3 REVISIONS TO THE DRAFT EIR

LAWRENCE BERKELEY NATIONAL LABORATORY
 SEISMIC PHASE 2 FINAL EIR
 REVISIONS TO THE DRAFT EIR

FIGURE 4.5-2
GEOLOGIC MAP OF THE EAST CANYON AREA

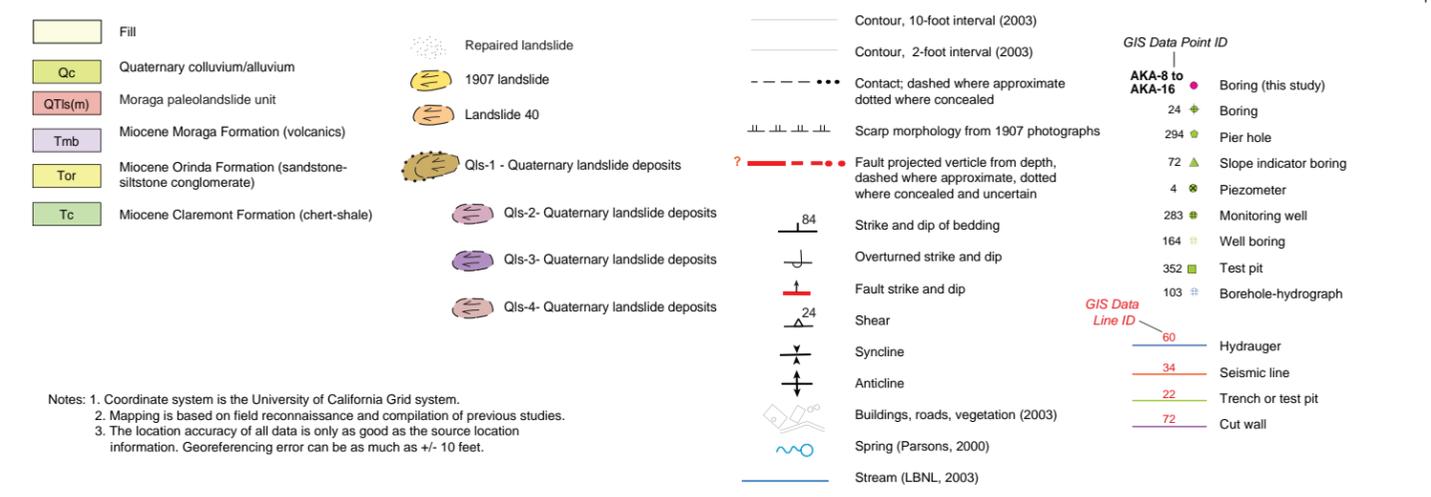
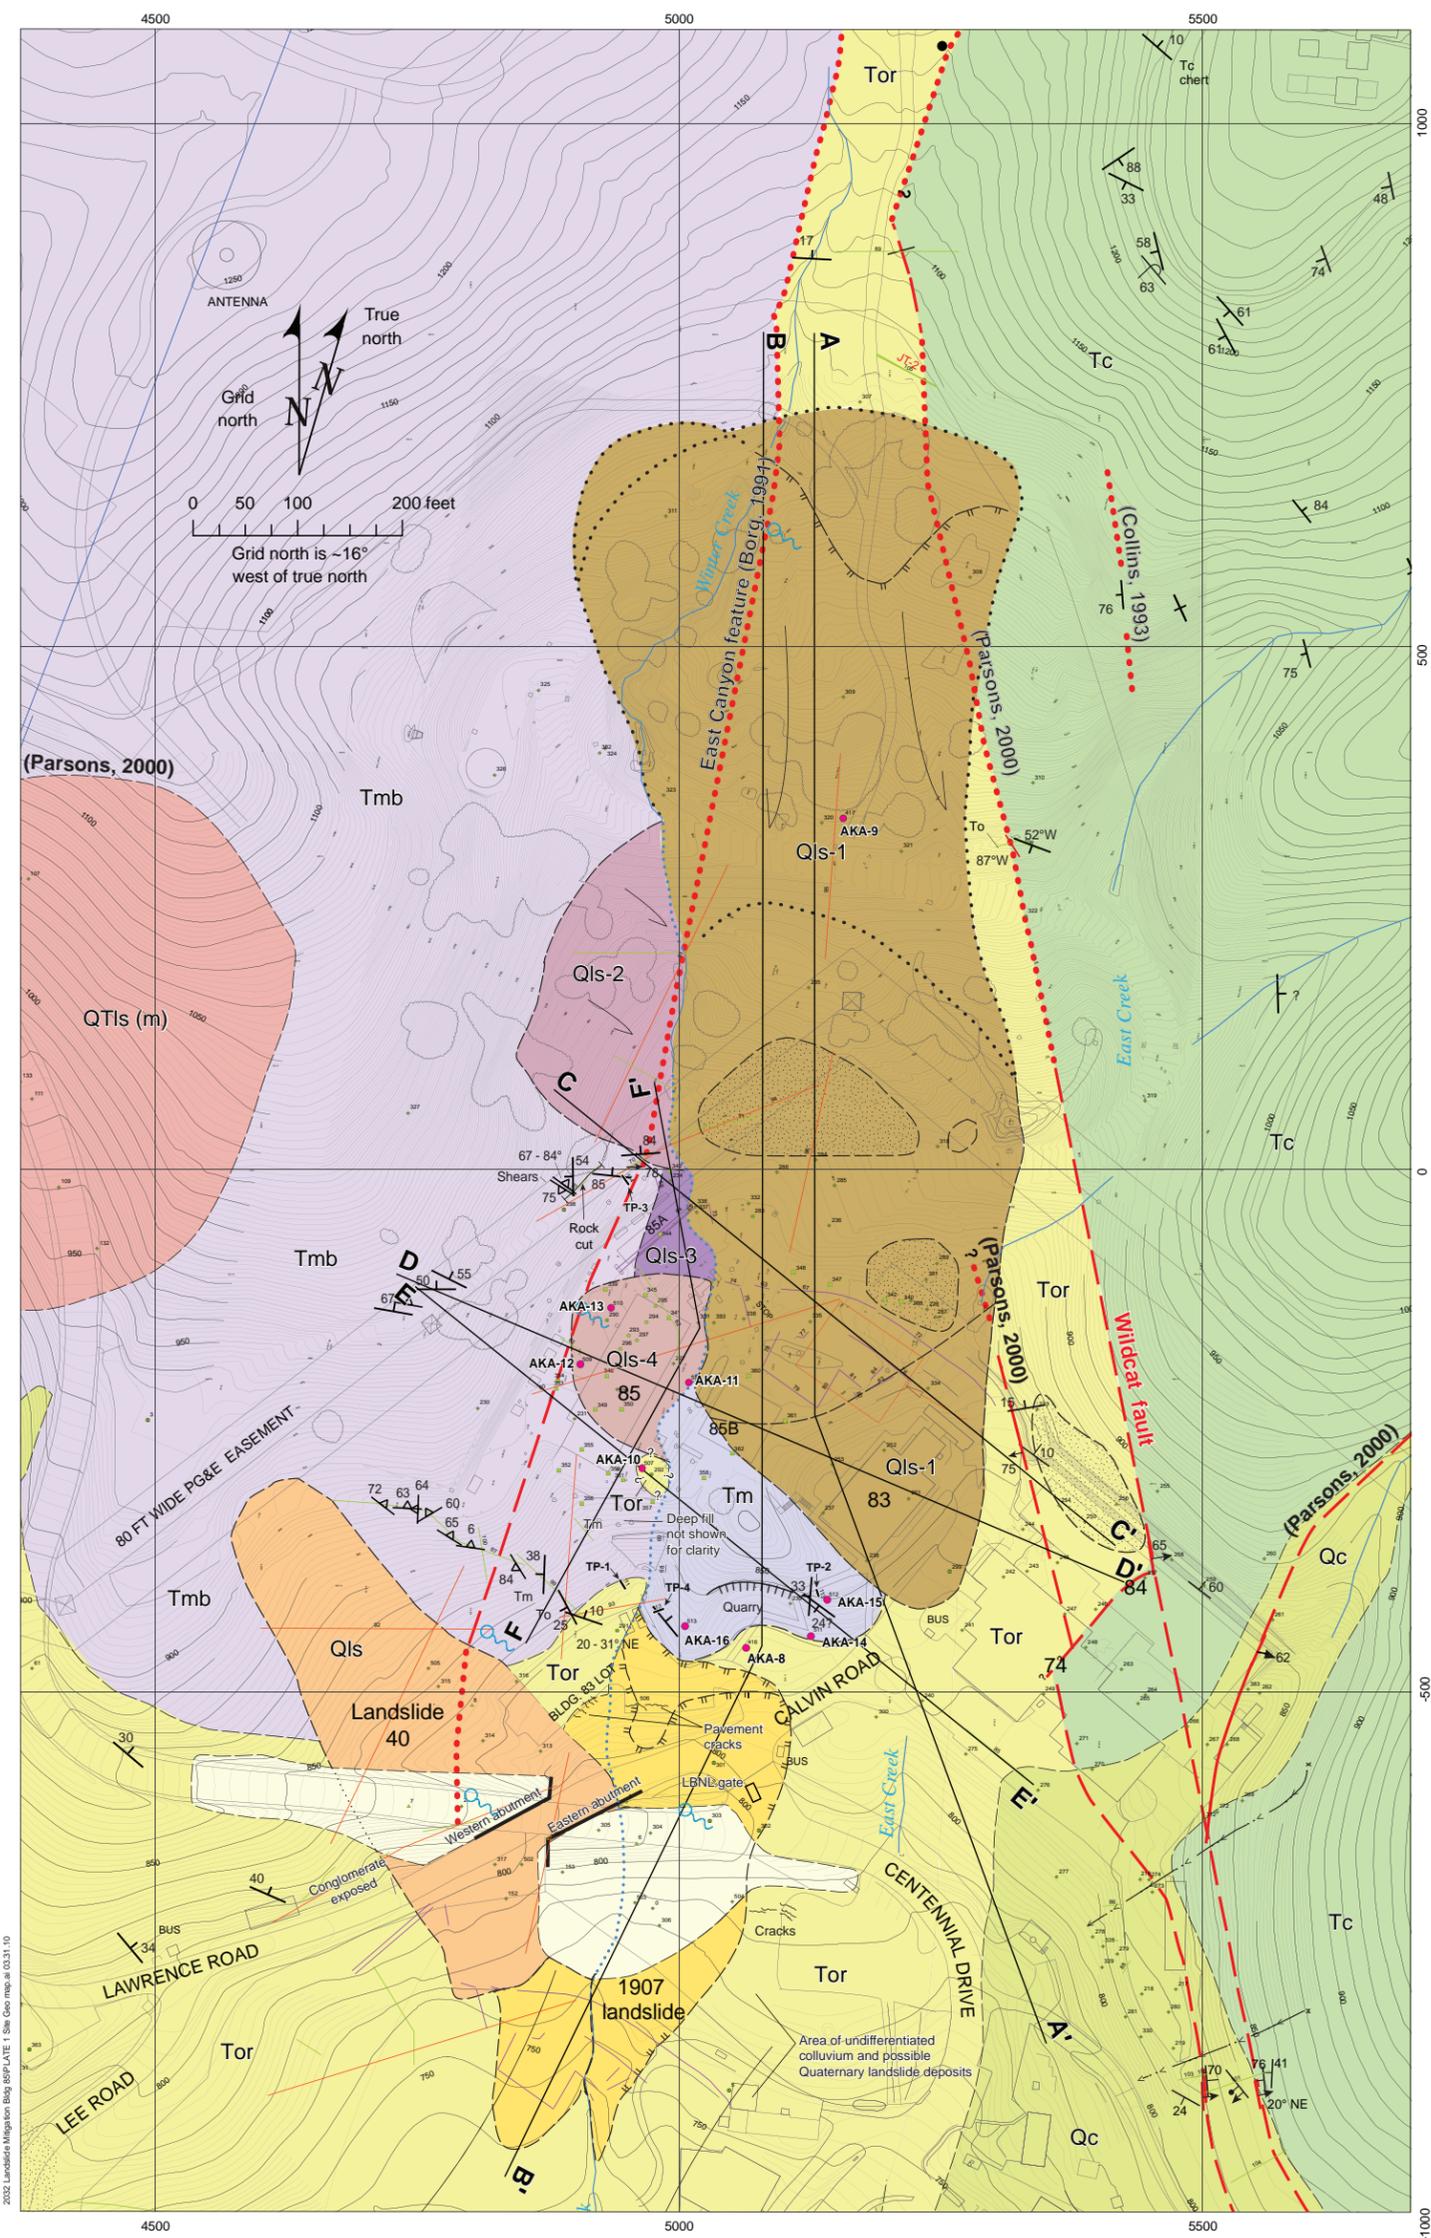
Figure 4.5-2 on page 4.5-13 of the Draft EIR is hereby replaced with the figure on the following page.
